SUBJECT: Megawind MX Wandering Hose Boom Pin Improvement

DATE: 06/15/2015

NUMBER: SB-0167

FIGURE 1

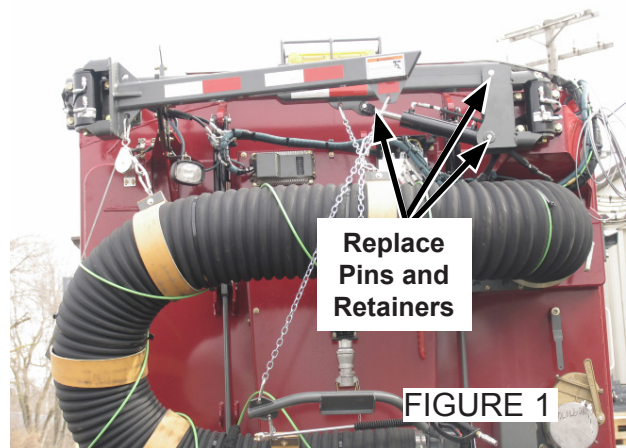
Megawind Wandering Hose Boom retaining pin hardware may loosen and fall out. Lost retainers may cause the boom to dislodge from the sweeper. (FIGURE 1)

FIGURE 1

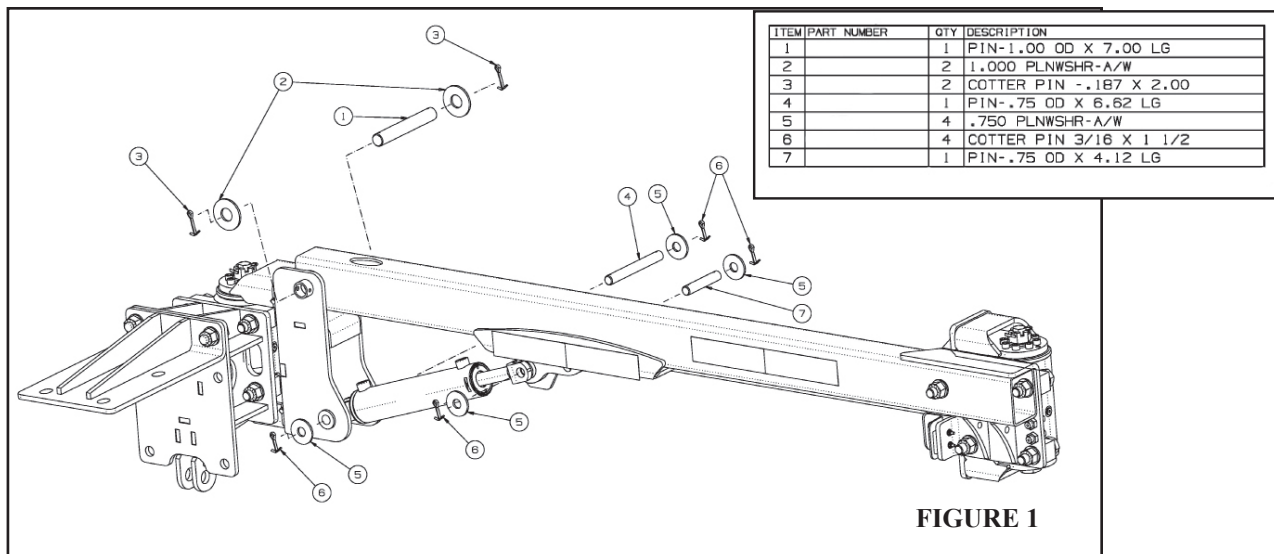
For all affected units - order and install FSO 1120239 Boom Arm Retention Fastener Kit. (FIGURE 2)

Install the FSO kit WH boom pins and retainers as instructed in the drawing supplied with the kit.
